Response to Further Advice for Development Application at 837–857 Waterworks Road, The Gap (Council Ref.: A007011234)

On behalf of *Aura Holdings Pty Ltd* ('the Applicant'), please find below response to the further issues requested by Brisbane City Council ('Council') in relation to the Development Application at 837 Waterworks Road, The Gap (Council Ref.: A007011234).

Figure 1 – Building height relationship to existing vegetation and surrounding context

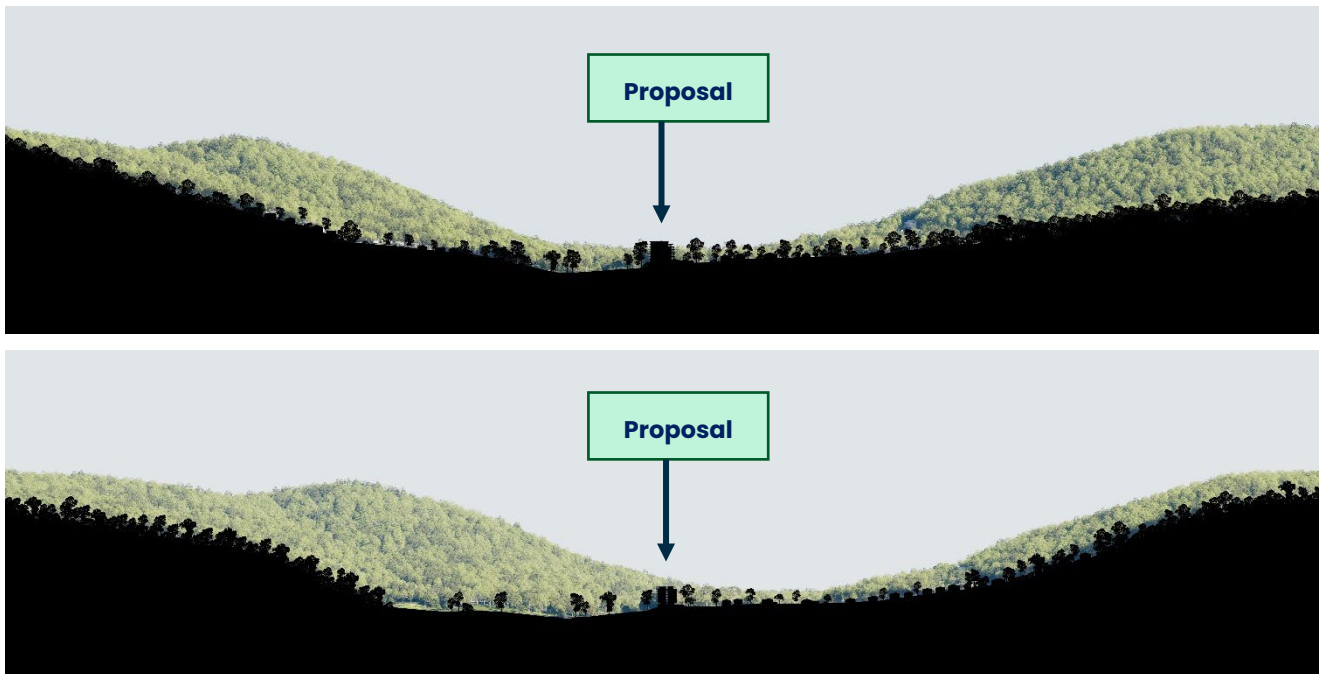
- b. Demonstrate the building height is commensurate with the height of existing mature street trees (including established gum trees) and significant vegetation on the site and how this vegetation contributes to mitigating the visual prominence of the development.

In response to Council's request regarding existing mature vegetation, the submitted sections demonstrate that the proposed building height is viewed within the context of the site's established landscape setting, including existing mature gum trees, significant retained vegetation and overall topography of the surrounding locality. The retained canopy vegetation provides a substantial visual foreground and backdrop to the development, assisting in softening views of the built form and mitigating its visual prominence. The proposed landscape outcomes further reinforce this character through additional deep planting and subtropical shade tree planting.

The existing mature canopy provides a strong vertical landscape context which currently defines the visual character of the site and assists in screening longer range views. As a result, the proposed built form will be read against, and partially filtered by, existing vegetation of comparable or greater height, rather than presenting as an isolated or visually dominant built element within the streetscape or locality.

Figure 2 – Perspectives

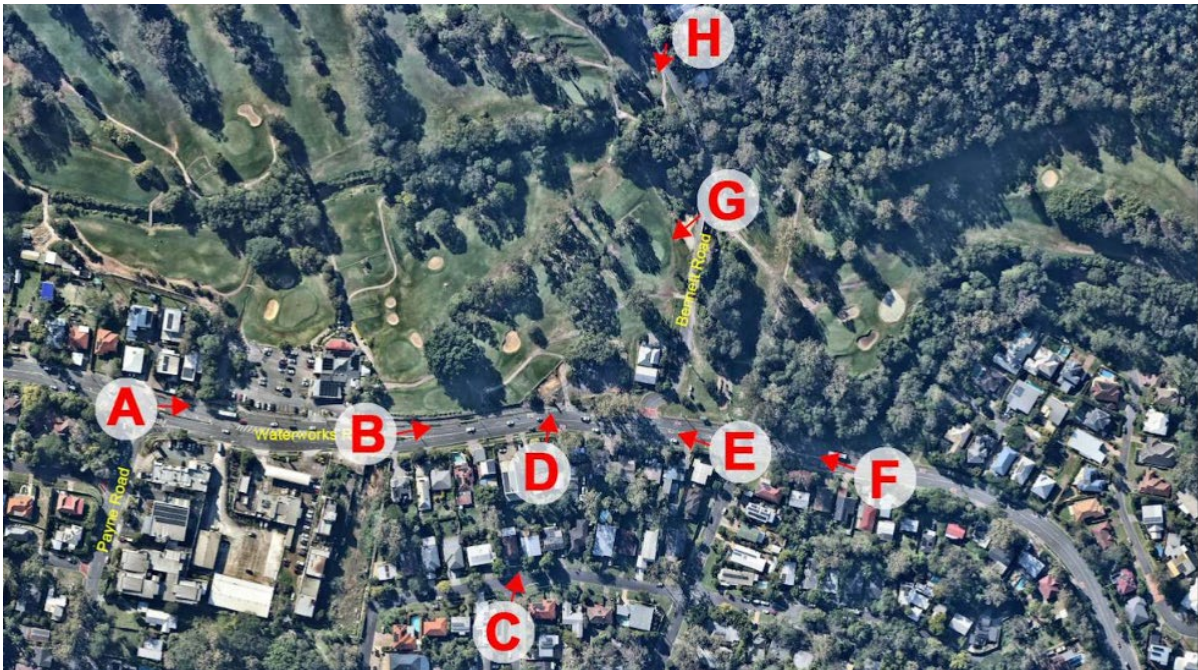
- a. In accordance with PO8 of the Retirement and residential care facility code, provide visual analysis including further perspectives and photo montages, demonstrating the visual integration of the development within its surrounding context. The analysis should include but not limited to, views from key focal points, views from residential properties and public vantage points along Waterworks Road, Payne Road and Bennett Road.

Eight perspectives have been created to provide a detailed understanding of the development's position and height context in comparison to the surrounding locality (see **Figure 2**). This is particularly relevant in assessing the visual prominence of the proposed height, as the development will not introduce an element that is materially higher than the established vegetated backdrop already experienced from surrounding viewpoints. The accompanying diagrams also demonstrate the relationship between the proposed built form, existing mature vegetation and surrounding topography, confirming that the perceived height of the development is moderated by the established landscape context.

Figure 5 – Irrigation Strategy

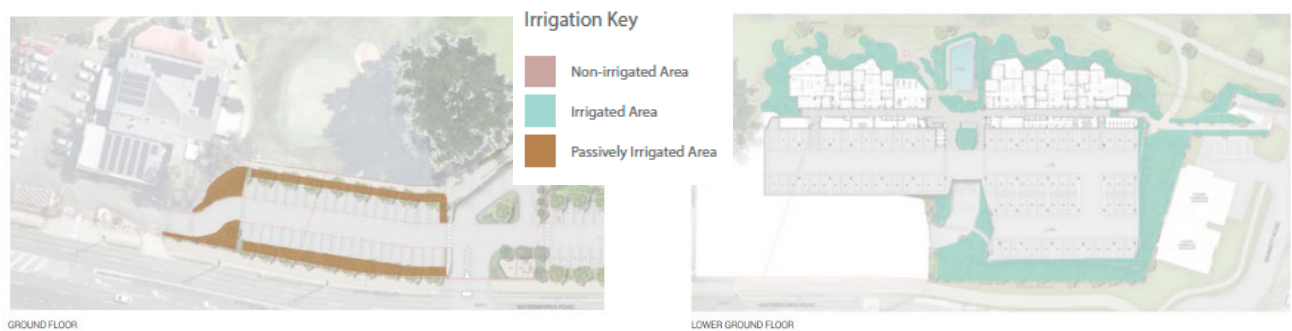
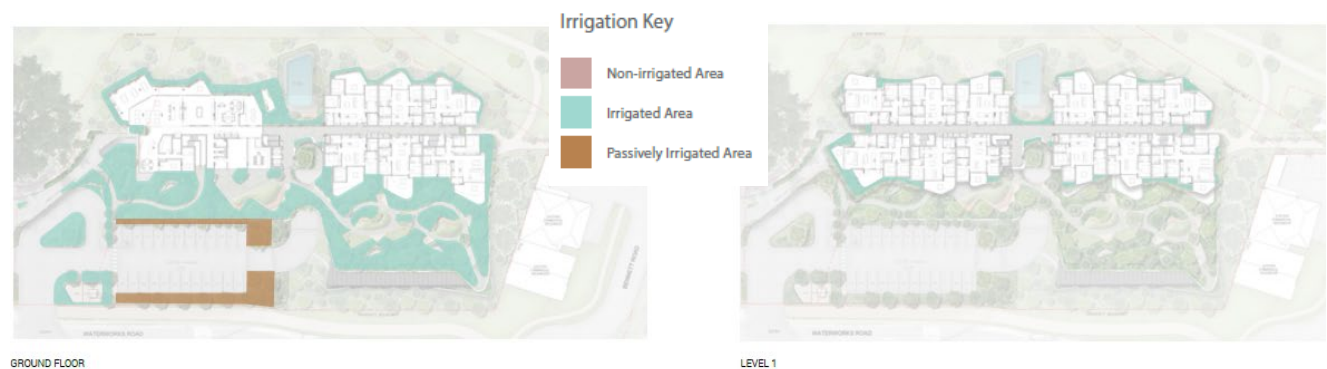
5. The proposal does not clearly demonstrate that adequate onsite water storage can be provided to support the proposed landscape measures on the site, including the significant quantity of containerised planting, and show the location of rainwater storage tanks.

- a. Amend the proposal and provide an Irrigation Strategy that outlines the requirements for the proposed stormwater harvesting and sufficient water storage methods, with reference to the Landscape works code (PO12, PO13 and PO15) and the Landscape design planning scheme policy.

In response to Council's request, a revised Landscape Concept Plan prepared by Place Design Group has been provided at **Attachment D**. The revised plan includes an Irrigation Strategy which outlines the proposed stormwater harvesting, water storage and irrigation requirements for the development, including the location, size and capacity of the proposed rainwater storage infrastructure.

The proposal will include a 310,000L rainwater storage tank and 10m² stormwater filtration tank located within the basement level, which will provide water storage to support the ongoing irrigation requirements of the proposal. The revised Landscape Concept Plan identifies the proposed irrigated, passively irrigated and non-irrigated landscape areas throughout the development (refer to **Attachment D** and **Figure 5** below). The landscaping around the open air car park fronting Waterworks Road, will be passively irrigated, while the

landscape areas within the ground floor and lower ground floor are proposed to be actively irrigated. Landscaping associated with the Level 1 to Level 6 podium planter areas will also be irrigated.

Figure 6 – Proposed Landscape Buffers – Waterworks Road and Eastern Boundary

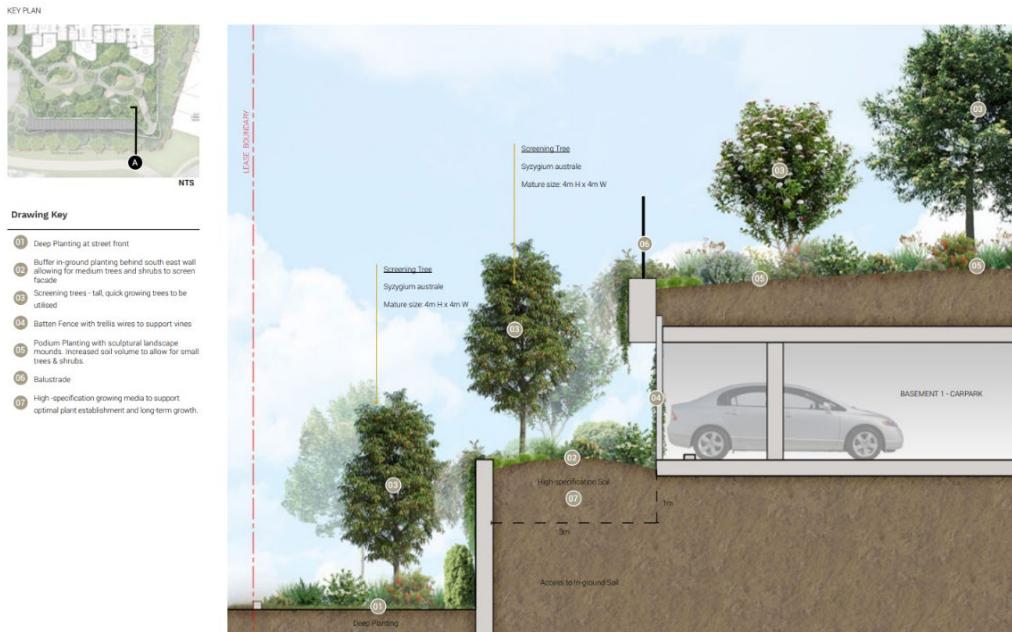
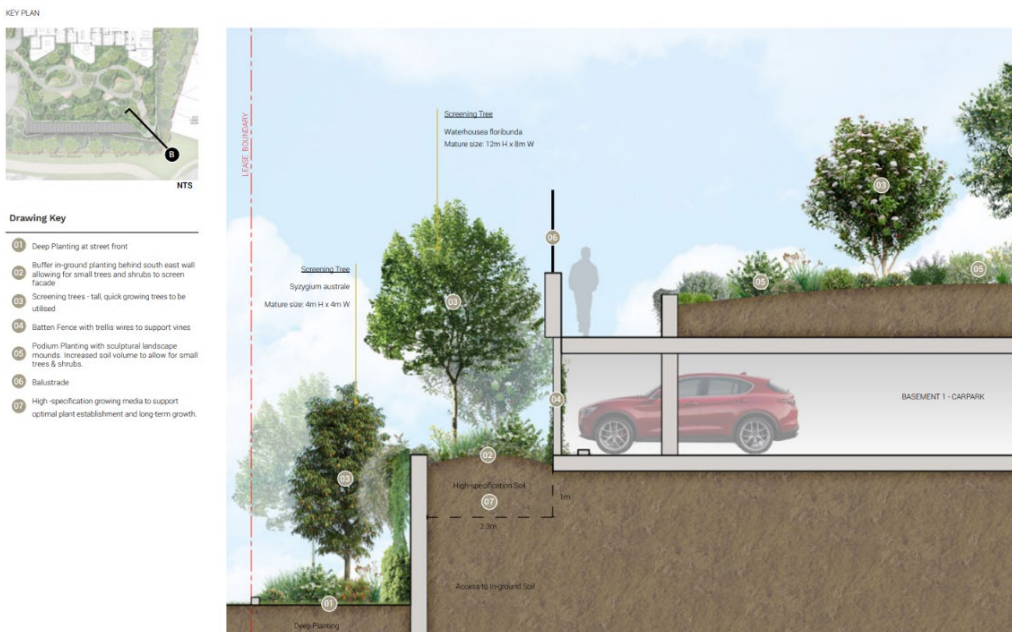
- a. Provide an amended Landscape Concept Plan prepared by a suitably qualified Landscape Architect that includes sections throughout the site that clearly demonstrate the proposed landscape outcomes along the boundaries in relation to the proposed built form;

- b. Include a minimum of 3 detailed planting plans of the proposed landscape buffers including adjacent to the open-air car parking, along the Waterworks Road frontage and along the eastern boundary. The plans are to include planting densities, stock sizes and a planting palette with a multilayered mix of fast-growing pioneer species and mature stock of slower growing species;

9. The proposed 1000mm soil depth containerised planter on the southeast corner of the site creates a constrained area of deep planting. Considering the built form outcomes in term of height, scale and setbacks from adjoining properties, this area would be more suited as inground deep planting. This outcome would ensure an improved interface with adjoining properties and allow for increased opportunities for large subtropical shade trees at this junction to address PO8, PO28 of the Retirement and residential care facility code.
 - a. Provide amended plans including a Landscape Concept Plan prepared by a suitably qualified Landscape Architect that removes the proposed 1000m containerised planter from the southeast corner and replaces with inground planting, incorporating additional large subtropical shade trees at this junction.

In response to Council's request, a revised Landscape Concept Plan prepared by Place Design Group (Refer to **Attachment D**). The revised plan includes boundary landscape sections demonstrating the relationship between the proposed built form and landscape outcomes, together with detailed planting plans for the landscape buffers adjoining the open-air car parking area, the Waterworks Road frontage and the eastern boundary (Refer to **Figure 6**).

The proposed 1000mm soil depth planter at the southeast corner of the site is proposed to be retained as it forms an important part of the overall built form and landscape response at this interface. Removal of the planter would result in a more exposed built edge and create the potential for an approximately three metre high wall presentation along the frontage. The planter provides an important landscape element which softens this frontage, reduces the visual prominence of built form and contributes to a more landscaped and subtropical interface with the adjoining properties and streetscape.

The planter will incorporate deep planting and a layered planting palette, including climbing species, to provide vertical greening and additional landscape screening. This will assist in visually breaking down the wall element, softening the presentation of the built form and reinforcing the subtropical landscape character sought by the Retirement and residential care facility code. On this basis, the retained planter achieves a preferable interface outcome compared with replacing this area with inground planting, as it avoids a hard wall presentation while still delivering meaningful planting depth and landscape screening at this junction.

Figure 10 – Refuse Collection Dimensions and Gradient

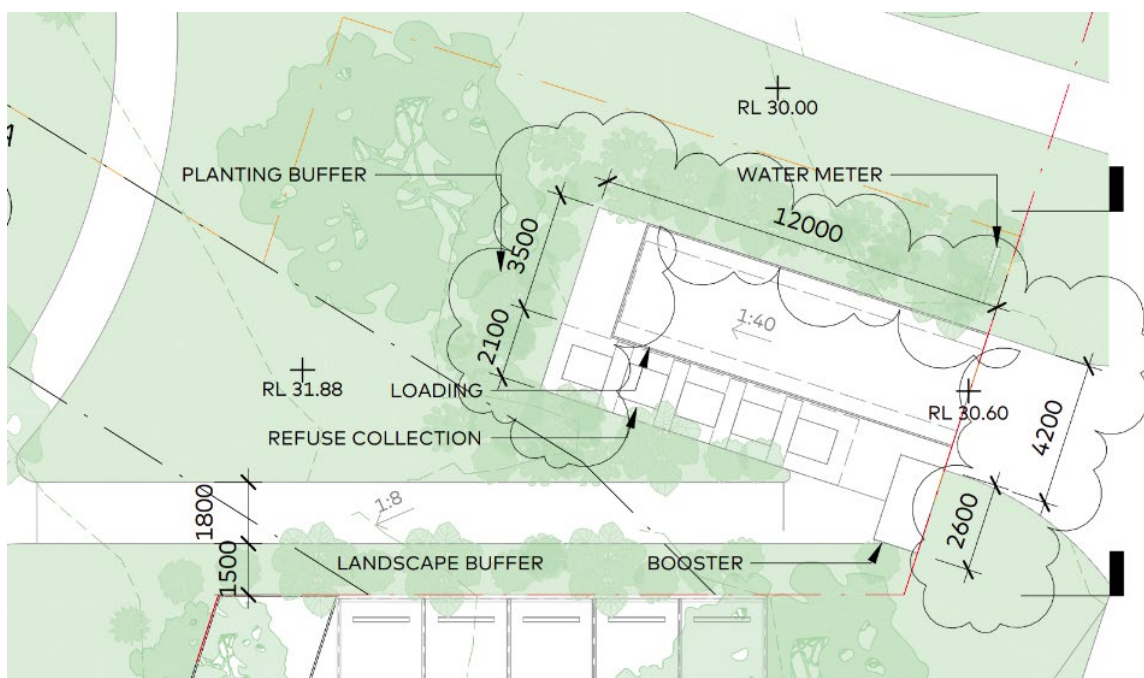
12. The submitted architectural plans do not specify critical design parameters of the proposed loading area, including its dimensions and gradient. This information is necessary to demonstrate compliance with the relevant servicing and manoeuvring requirements.
- a. To demonstrate compliance with PO4/AO4.1 and AO4.2 of the Retirement and residential care facility code and PO8/AO8.1 and AO8.2 of the Infrastructure design code, submit amended architectural drawings that clearly identify and detail the length and width of the loading area and the longitudinal and crossfall gradients of the loading area. The provided information must demonstrate that the loading area is appropriately designed to safely and efficiently accommodate waste servicing vehicles in accordance with Council requirements.

The Waste Management Plan confirms that waste servicing will occur from the dedicated Bennett Road loading bay designed to accommodate Brisbane City Council's rear-lift waste collection vehicle, with appropriate clearances, safe vehicle manoeuvring, and a refuse vehicle standing area constructed to a maximum gradient of 1:40 in accordance with Council's refuse, transport, access, parking and servicing requirements.

Amended architectural drawings have been prepared to ensure the dimensions and gradients are accurately shown for the loading bay and waste servicing area, as shown in **Figure 10** below.
